MEMO

Consent number: RM22-0010

Technical audit: **Te Puna Industrial Limited**
Application for earthworks and permanent discharge of stormwater to water

From: [Rob Donald](#)
To: [Marcia Christian](#)
Subject: Science Review - RM22-0010 - Discharge Sampling to Created Wetland
Date: Friday, 18 March 2022 4:01:55 pm

Figure 1: Proposed Earthworks Plan and Site Layout

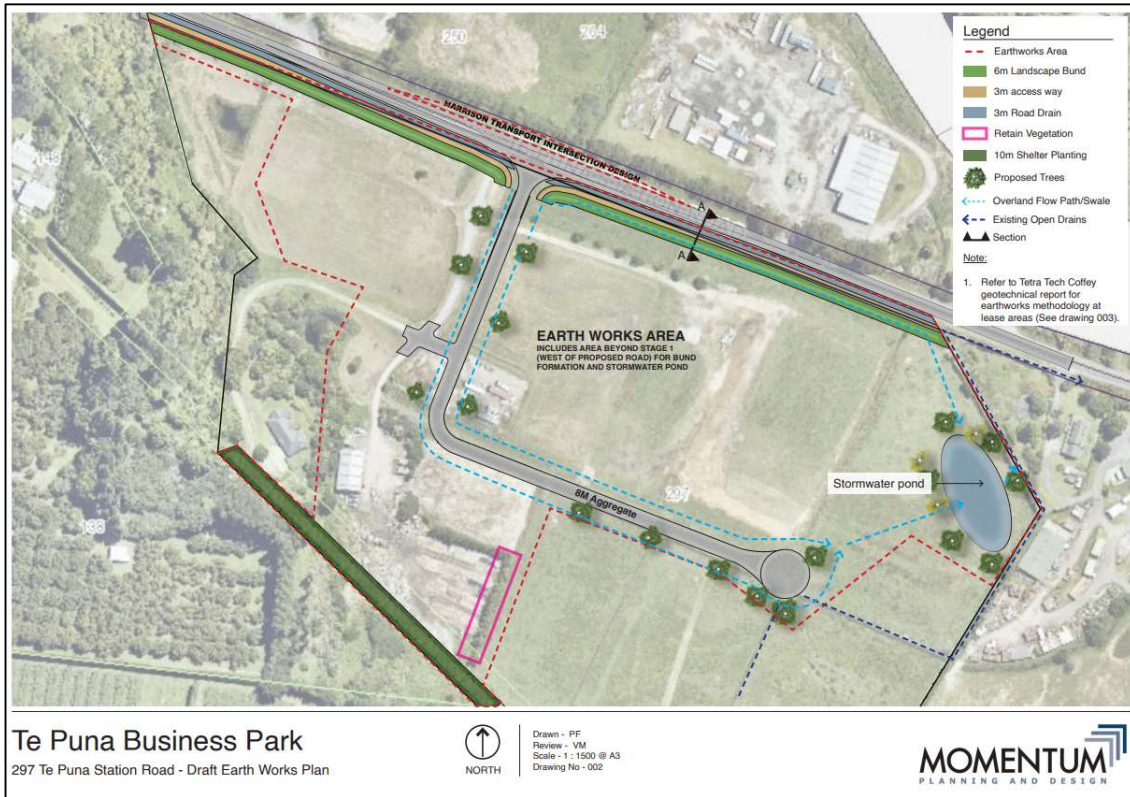
3. Where should sampling occur and how often?

I would recommend monitoring at least 6 times per year during rainfall events (with sampling events no closer than 1 month apart to give a seasonal spread). Sample stormwater at the discharge from the treatment wetland to the roadside drain.

Figure 2: Proposed Activities Plan at the Site

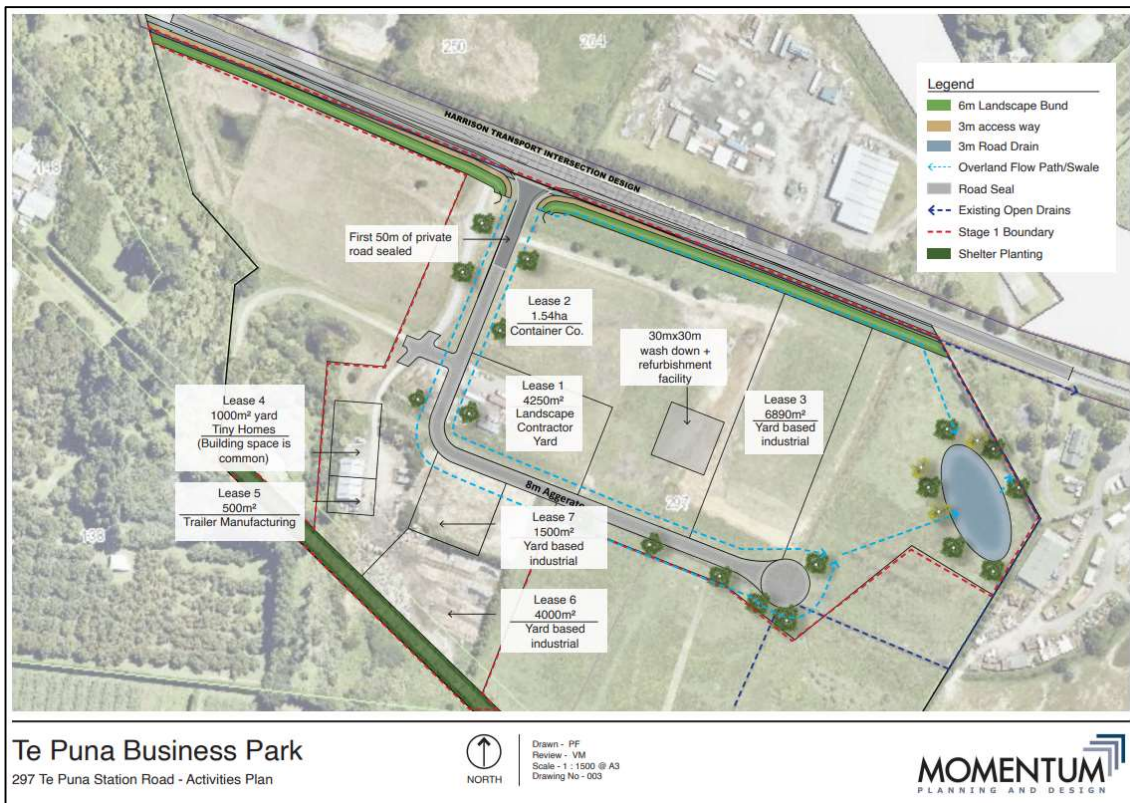
2. Will the proposed wetland adequately manage these expected contaminants, or should there be some pre-treatment before stormwater enters the wetland?

As above, it is difficult to comment without an understanding of future activities. Certainly for the ContainerCo operation the proposed stormwater treatment device (Fox Valve, Stormwater 360) appears to be adequate, provided it is used to treat stormwater and not wash water from paint stripping etc. This process should have its own treatment system. The proposed swales and wetland mitigates the risk to some extent although I note that this will be bypassed during larger rainfall events.
